COLERAIN TOWNSHIP ZONING COMMISSION

Regular Meeting **Tuesday, July 21, 2015 - 7:00 p.m.**

STAFF REPORT:

CASE #: ZA 11-88

9693-CD

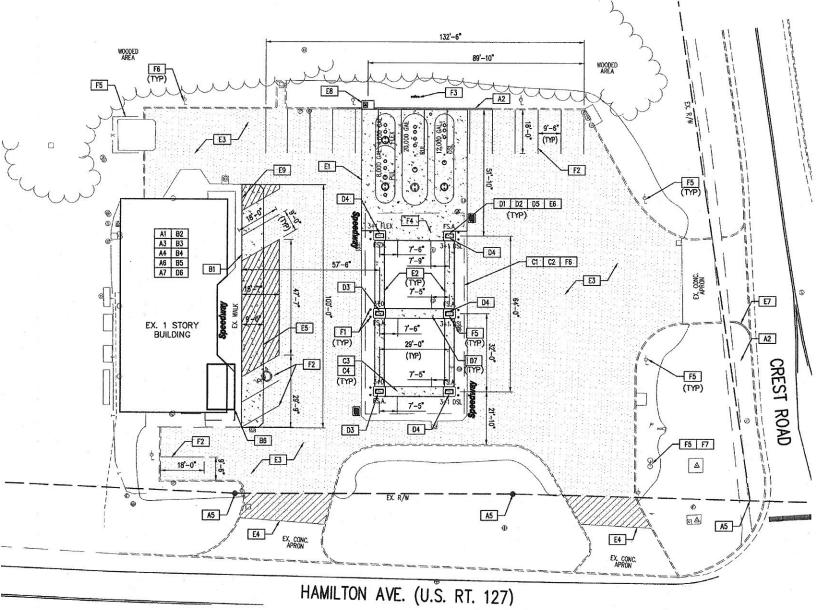
PROJECT The applicant proposes to add a 58 SF building addition to the front of the existing conve SUMMARY: building to serve as a beer cave. The beer cave will protrude from the front wall into the flower bed. In addition, exterior upgrades are proposed, including an interior remodel as replacement of gas tanks, lines, and dispensers on the site. Exterior upgrades will require replacement of some concrete and a new overlay of asphalt on the site.

Landscaping: The applicant proposes to remove the raised landscape bed on the west sid building, where the beer cave addition will extend out from the building. All other existi landscaping will remain. The applicant proposes to replace any landscape material that damaged due to the gas tank replacement.

RECOMMENDATION: Staff recommends approval of the Minor Modification to the FDP

9693-CS

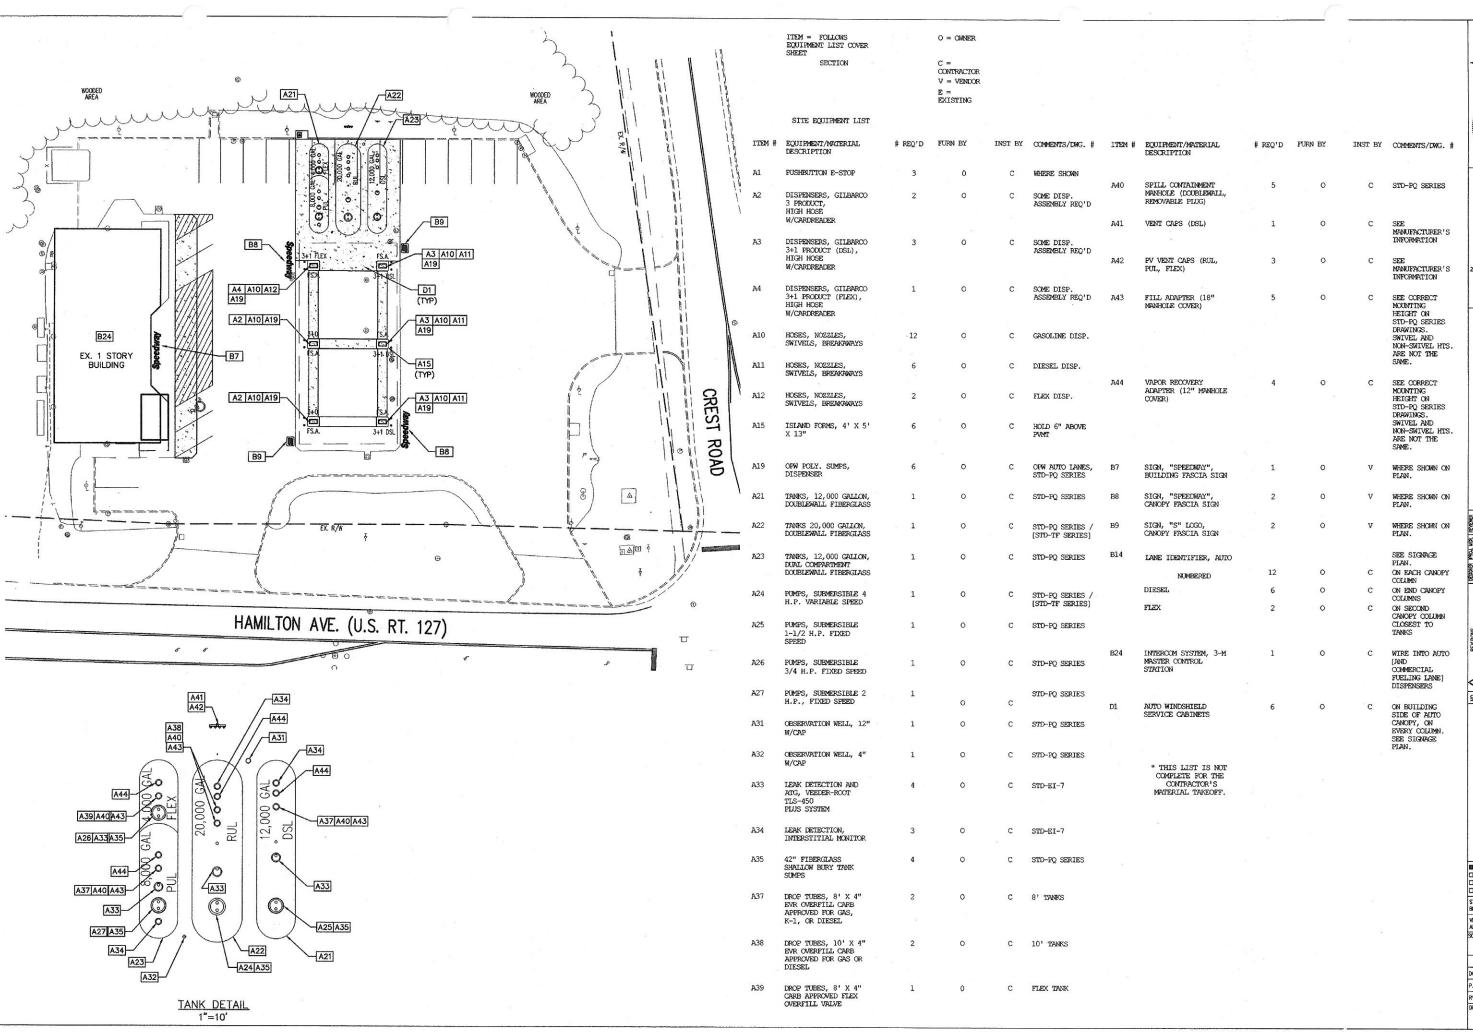
CONSIDERATIONS: Building: The existing building is 3,794 SF and an addition 58 SF of building is proposed of 3,852 SF of building. There are no restrictions on building size associated with the preapproved FDP or the PD-B zoning district.

Parking: The applicant is proposing an increase in parking spaces from 16 to 20. The par requirement for automotive fuel sales is 4 per 1,000 SF of floor area plus 1 space per fuel section 13.3.2 of the zoning resolution). Therefore, the addition of 4 parking spaces brin closer to the current standard, which would be 21 spaces (15 for floor area, plus 6 for pur
